PUBLIC HEARING VIII MEMORANDUM

PETITION #09-22

60 Charlemont Street and 56 Christina Street

Date: August 29, 2023 Job No.: 10707
Katie Whewell, Chief Planner for Current Planning
To: Michael Gleba, Planning Department
City of Newton
Cc:
From: Jeff Maxtutis, BETA Group, Inc.
Subject: **The Northland Charlemont Street Development
Transportation Peer Review of VHB Memorandum August 17, 2023**

Figure 1 Map of Routes with Average Travel Times

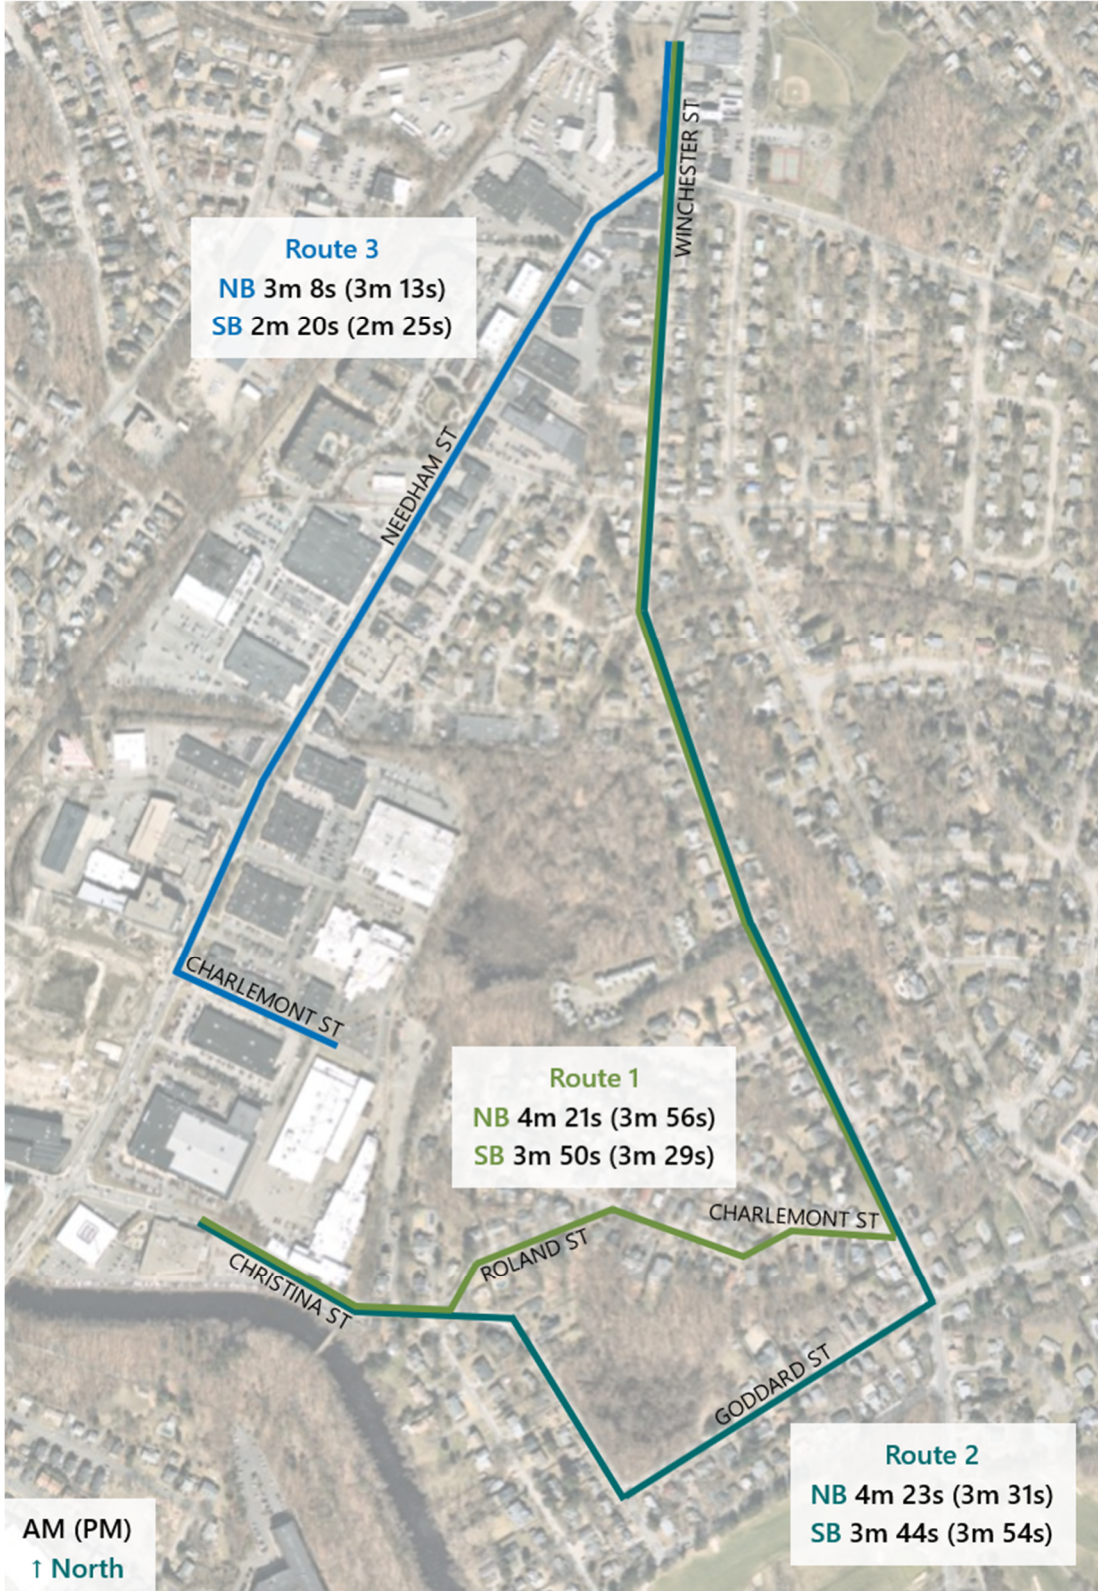
BETA Comment 3: *The travel time results appear reasonable. As noted in Comment 1 above, more traffic may temporarily use local roadways if there is an incident, crash, or construction on Needham Street,*

As shown in Figure 1 and Table 2, the quickest travel route between the Site and points north on Winchester Street is via Needham Street. Traveling between points north on Winchester Street and the future Site driveway on Charlemont Street via Needham Street is over one minute faster in the morning and over 15 seconds faster in the evening than traveling between points north on Winchester Street and the future Site driveway on Christina Street via Winchester Street and the residential neighborhood streets. Therefore, it is expected that most traffic to/from points north will avoid the residential neighborhood and will travel on Needham Street instead.

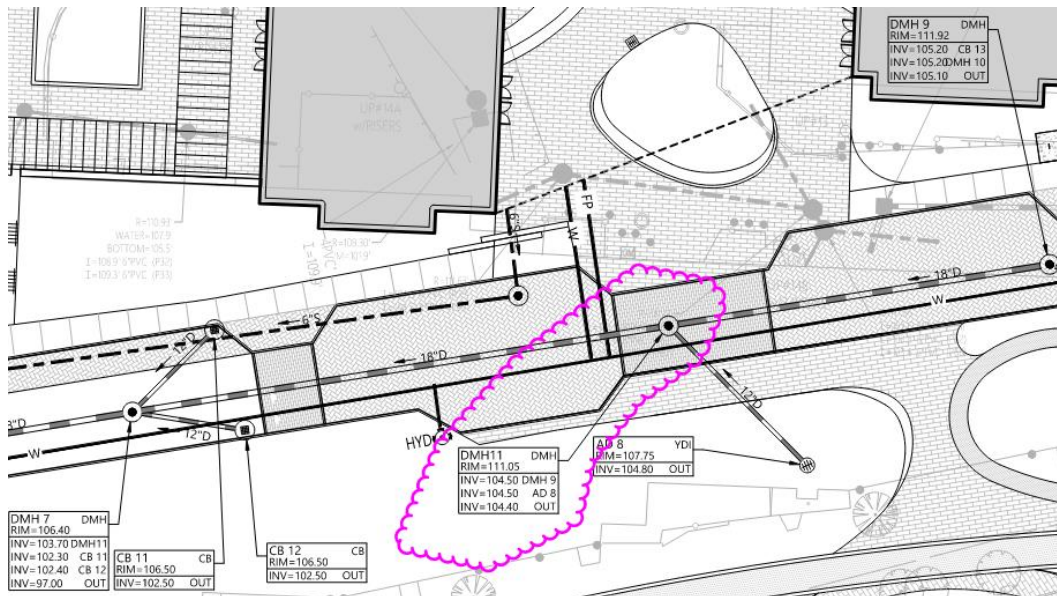
Page 6 comment I. – We have a small difference of opinion about whether a drain manhole is needed/required at the area drain connection, but we added the manhole for expediency to close out the comments. Please see a screen capture from the re-plotted site plan below.

Page 9 comment 9 – We have corrected the plotting/drafting issue and the plan title is now readable. Please see a screen capture from the re-plotted site plan below.
